# EMERGENCY ALERT SERVICE BULLETIN

**Tail Gear Box (TGB) P/Nos. 365A33-6005-09 and 365A33-6005-10**

HELICOPTER(S) CONCERNED	NUMBER	Version(s)	
		Civil	Military
AS365	01.00.71	N, N1, N2, N3	F, Fi, Fs, K, K2
AS565	01.00.24		CA, MA, MB, MBe, SA, SB, UB
EC155	04A016	B, B1	
SA366	01.31		GA

Revision No.	Date of issue
Revision 0	2019-10-24
Revision 1	2019-12-11
Revision 2	2020-03-25
Revision 3	2021-06-14

Figure 1: Example of abrasion on the chip detector

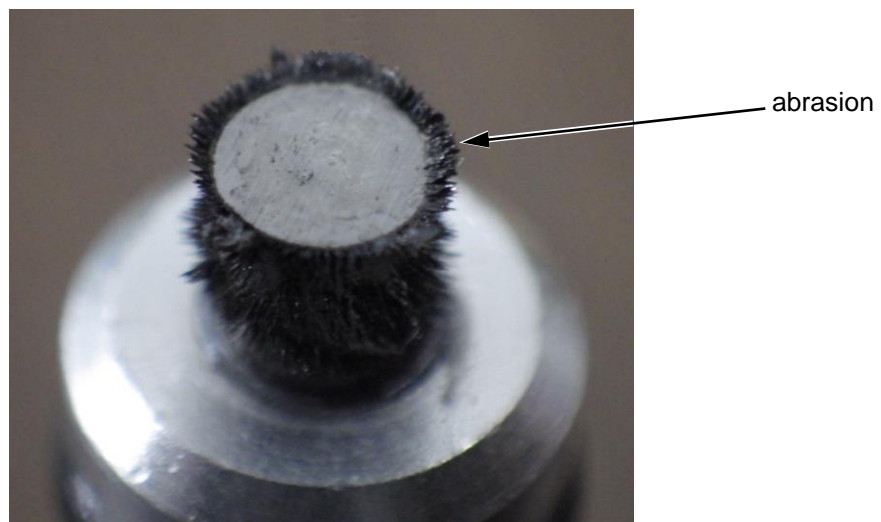
**IN THE FLOW CHART, THE ABRASION PARTICLES (CLASS g AS PER MTC) MUST BE TAKEN INTO ACCOUNT IN ADDITION TO THE PARTICLE TYPES USUALLY TAKEN INTO ACCOUNT.**

Figure 2 (Washing of the double bearing)

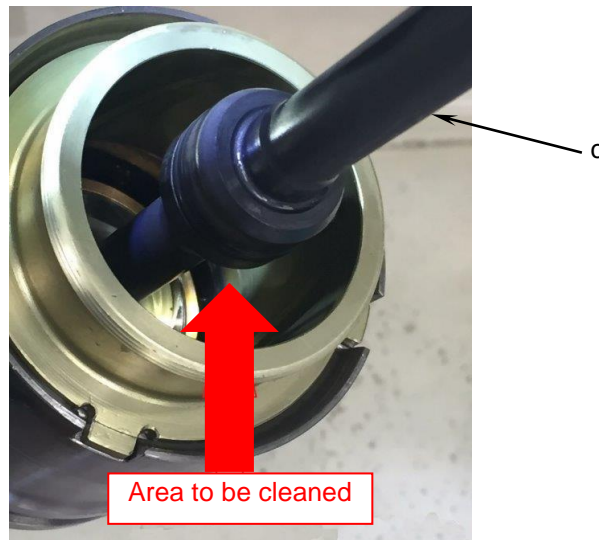
- 1) Insert WHITE SPIRIT (2) under pressure (for example using a can) in the hole (a) of the control shaft (b). **(See [DETAIL A Figure 2](#)).**
    - . Manually turn the control rod (c) several times to wash the double bearing (d) by draining the WHITE SPIRIT (2) through the bearing. **(See [Detail A Figure 2](#))**

- 2) Insert WHITE SPIRIT (2) (for example using a can) in the area of the control shaft (b) that must be cleaned. **(See [DETAIL B Figure 2](#)).**
    - . Manually turn the control rod (c) several times to wash the double bearing (d) by draining the WHITE SPIRIT (2).

*Make sure that the area pointed out in [DETAIL B Figure 2](#) is clean.*

Figure 3

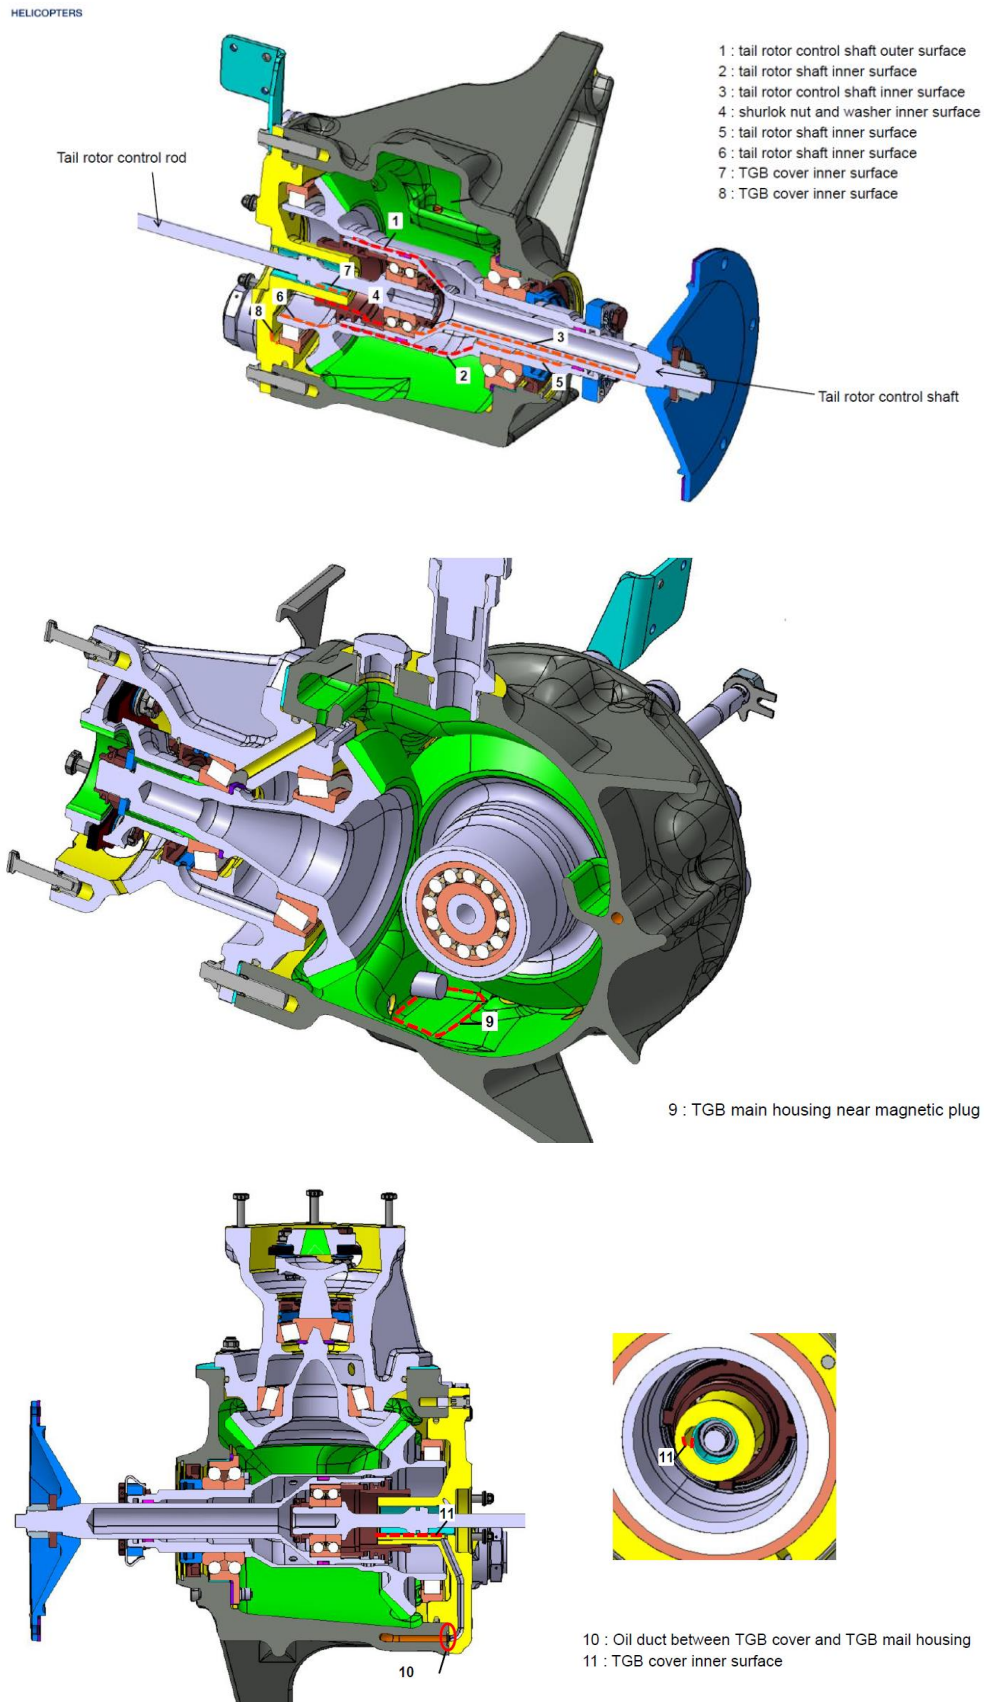
- Check that there are no particles in the lubrication hole of the TGB cover (Area No. 11, [Figure 3](#) of APPENDIX 4.B.).
- Install the TGB control shaft/rod assembly as per Work Card 65-21-00-701 (MRM) or as per Task 65-20-01-066 (AMM).

Complete APPENDIX 2 (see [Figure 3](#))
